Work Order ID 140422

Item Name: Fwd Crosstube - High 407

DART AEROSPACE LTD		Work Order: 140422
Description: Crosstube High Fwd (407)		Part Number: D407-667-105
Inspection Dwg: D407-667-145 Rev: C		Page 1 of 1

DRAWING NO. D407-667-145	TITLE CROSSTUBE ASS'Y (407 HIGH FWD)	REV. C	DART AEROSPACE LTD ENGINEERING ORDER		D.E.O. NO. D407-667-145-C-1	SHEET NO. SHEET 1 OF 1	SCALE NTS
DRAWN 97	CHECKED ASS	MFG. APPR. IB	APPROVED MD		DE APPR. H		
DATE 11.07.15	DATE 11.07.22	DATE 11.07.22	DATE 11/07/22		DATE 11.07.21

DETAIL P
BONDING STRAP INSTALLATION 2 PL

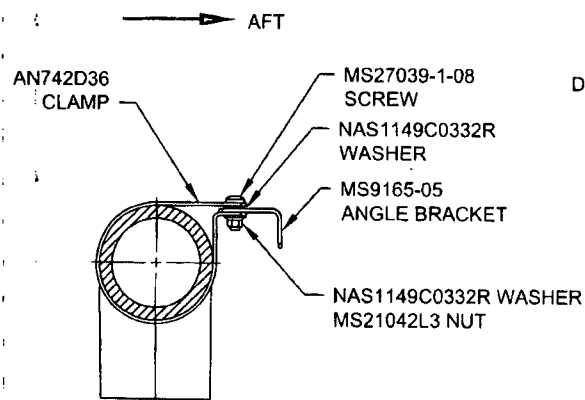
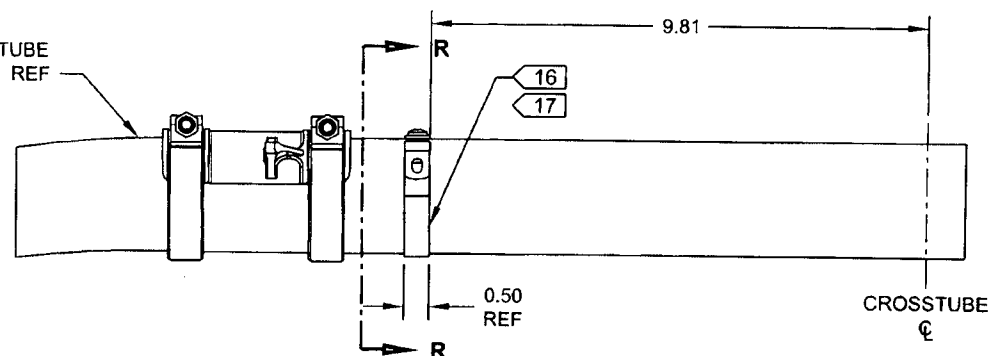
ADD ELECTRICAL GROUNDING STRAP

ITEM	QTY	PART NUMBER	DESCRIPTION
1	X	D407-667-145	CROSSTUBE ASSEMBLY (407 HIGH FWD)
10	2	AN742D36	CLAMP
11	2	MS9165-05	ANGLE BRACKET
12	2	MS21042L3	NUT (OR MS21042-3)
13	2	MS27039-1-08	SCREW
14	4	NAS1149C0332R	WASHER (OR AN960C10L)
